**Proposal for Supplement 4 to the 04 series of amendments to Regulation No.48**  
**(based on ECE/TRANS/WP.29/GRE/2007/60)**

**\*Bold part was updated from the document of ECE/TRANS/WP.29/GRE/2007/60**

"6.25. REAR-END COLLISION ALERT SIGNAL

# Vehicle test of Rear-end Collision Alert Signal

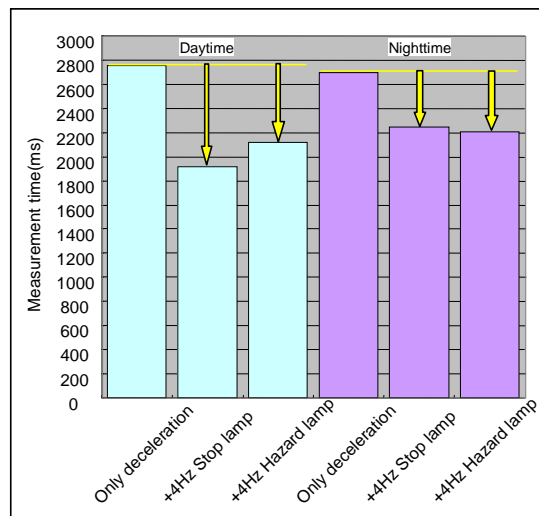
rear-end collision alert signal: ~~red or~~ **amber**

**Although Japan investigated each effect on the color between red and amber (next page), we could not see a significant difference. Thus,** Japan has found that the color of the lamp does not contribute to make the driver of the following vehicles, who is preoccupied, recognize the danger. **On the other hand, the rear end collision alert signal can be activated automatically by the vehicle distance detection without the brake pedal application. Therefore, amber color (i.e. all the direction indicator lamps) is suitable for the current road traffic use situation and custom.**

According to the test result, there is no significant difference between red and amber on the whole.

**Para.6.25.7.5 - 6.25.7.7:**

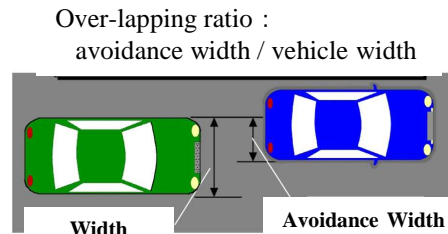
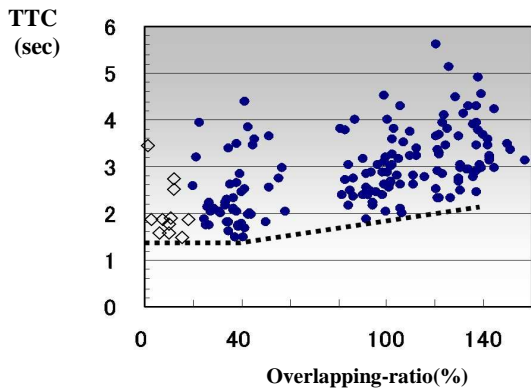
- 6.25.7.4. The rear-end collision alert signal shall not be activated during the ESS activation.
- 6.25.7.5. **The rear-end collision alert signal shall not be activated where;**

(a) **the relative speed between leading and following vehicle is not more than 15km/h and**  
(b) **the estimated time to collision (TTC) which is the time obtained by dividing distance by relative speed between following vehicle and leading vehicle is more than 1.4 seconds,**

**but it is allowed to be activated anytime when TTC is not more than 1.4 seconds, the actual value being defined by the vehicle manufacturer.**
- 6.25.7.6. **The rear-end collision alert signal shall not be activated when the following vehicle passes the forward vehicle.**

- 6.25.7.7. **The activation period of the rear-end collision alert signal shall be not more than 3 seconds.**
- 6.25.8. Tell-tale  
Optional"

**The intention of these requirements is the Rear-end collision alert signal would not activate at the area of ordinary driving operation. Under ordinary driving, the timing which Drivers begin steering for obstacle avoidance is as follows. (In Japan)**

**According to the above result, if the system is activated at  $TTC \leq 1.4$  s, you can find there is no influence to the ordinary driving operation, thus the rear-end collision alert signal does not make the unexpected effect to the road safety.**

**If there are frequent warning signal which are ignored by the driver of the following vehicle because they are too early to warn, the rear-end collision warning signal may lose driver's trust and it will fail to alert and/or annoy the driver of the following vehicle. This "distrust" and/or "annoyance" to the warning system needs to be reduced as much as possible, especially at the first introduction of such an "advanced signal" to the market. Thus the activation of this warning signal permits within only the limited condition that there is no influence to the ordinary driving operation in consideration of the current technology.**

**Besides, this signal should not be activated under very low relative speed to avoid the annoying for driver in the following vehicle because it is more likely to be flashing under very low speed.**
